Maritime &
Coastguard
Agency

Our ref: Thanet Extension Offshore
Windfarm Project (EN010084)

Thanet Extension Offshore Windfarm Project (EN010084) Examination Authority Actions and Questions

0	0.65	1.3 NM	0	1	2 km
Drw No	2.5	TEOW_Offshore_works_plans	Date	22/06/2018	
Rev	0.1		PN	Check	ISL
By

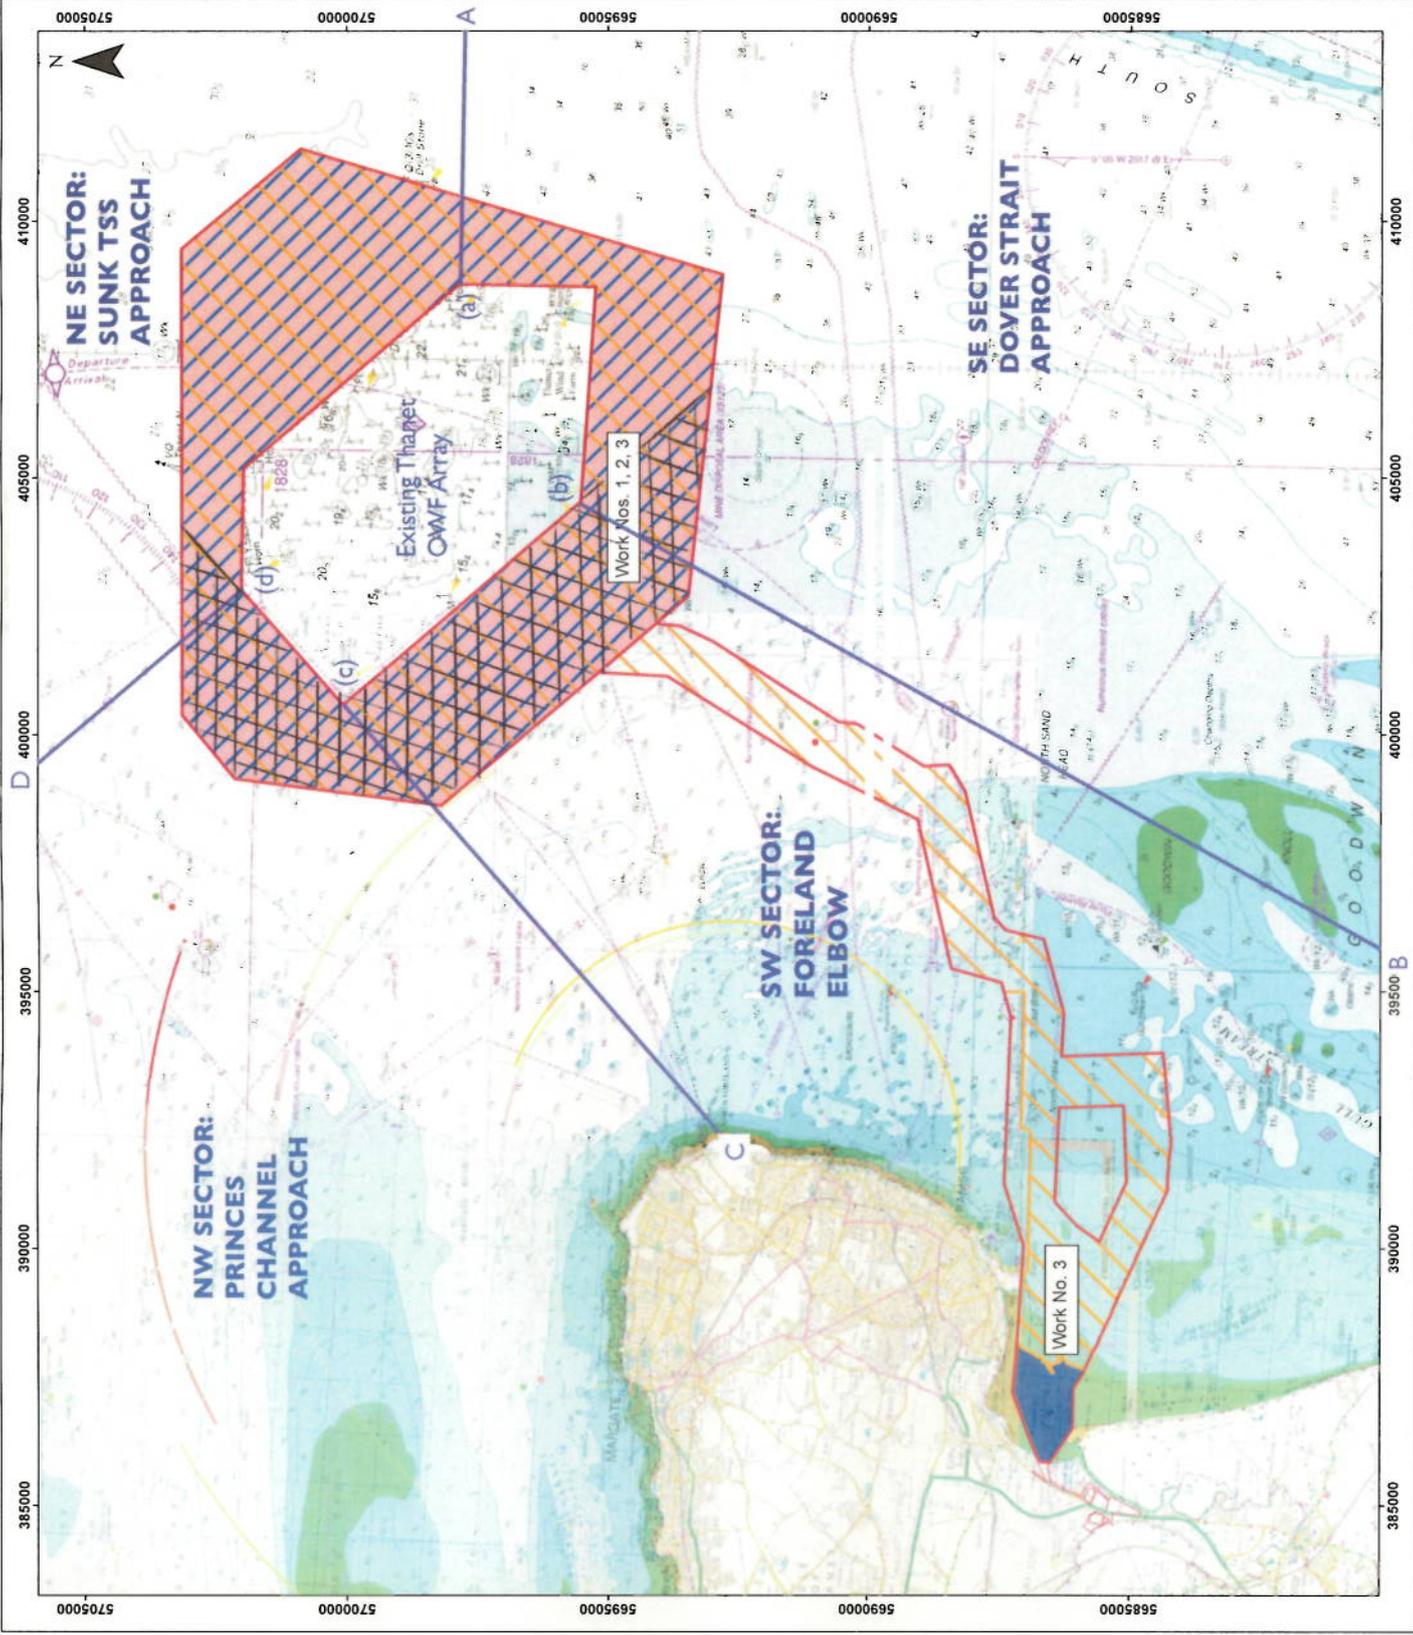
See attached image.

There is a clear increase in risk with a significant reduction of available sea room on the western extent, in an already highly complex area for navigation. This means; a) the frequency of encounters increases, b) small vessels are closer to bigger vessels, and there is a reduced margin of error for pilot boarding arrangements. Whilst it is understood that the NRA mentions only a limited impact to traffic routing, it is evident that the traffic passing between the windfarm and the Kent coast will be squeezed further to the west.
